Change Bulletin No: CB046 Rev: 0 Date: 14 Sept 2011 Update EXI Gearbox Seal and Grease Procedures Tesco Corporation 5616 – 80th Avenue SE Calgary, Alberta, Canada T2C 4N5 Tel: 1-877-TESCO-77 (North America) Tel: 1 (713) 359-7195 (AMSS 24-hour support) Tel: 1 (713) 359-7295 (International) Email: bulletins@tescocorp.com www.tescocorp.com www.tescocorp.com www.tescocorp.com www.tescocorp.com www.tescocorp.com

Figure 1: Upper bearing retainer (side view)

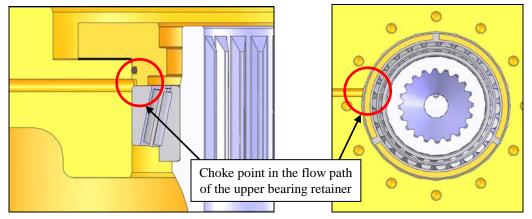
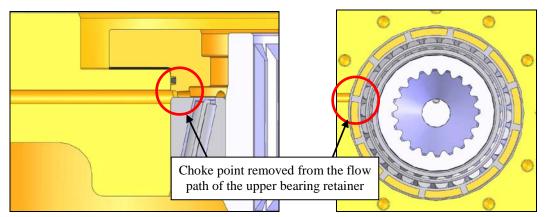
Four EXI Top Drives have been identified to be leaking gearbox oil from the upper section of the gearbox. These incidents occurred even though the top drives were operating for very short periods of time. After investigation, it was discovered that a choke point in the flow path of the upper bearing retainer (P/N 810387) caused an unwarranted increase in pressure (Figure 1 and Figure 2).

TESCO has modified the flow path for the gearbox upper bearing retainer (Figure 3 and Fi gure 4), removing the choke point to eliminate any reoccurrence of increasing pressure.

Figure 5: PolySeals on lower bearing retainer

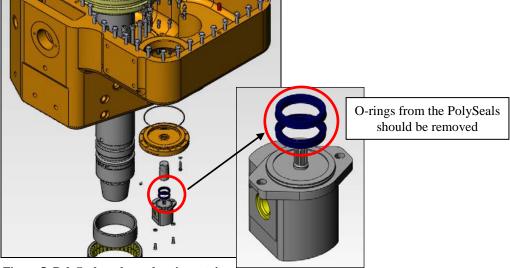
It was also found that the lower bearing retainer seals on the main pinion were wearing out prematurely due to improper installation. This, in combination with low grease levels surrounding the pinion, was compromising the seals and leading to premature seal failure.

EXI illustrations have also been updated to clearly communicate greasing procedures and to ensure that the O-rings from the PolySeals (P/N 820275) on the lower bearing retainer (P/N 820274) are removed to reduce excess wear on seals (Figure 5).

When installing PolySeals on the EXI lower bearing retainer, ensure that the O-rings are removed from the PolySeals before installation.

Before completing the EXI gearbox assembly, a minimum of 10 shots of grease (P/N 510486) must be inserted into the grease port attached to the lower bearing retainer, along with 1-1/2 tubes of grease being put into the upper cavity of the motor pinion.
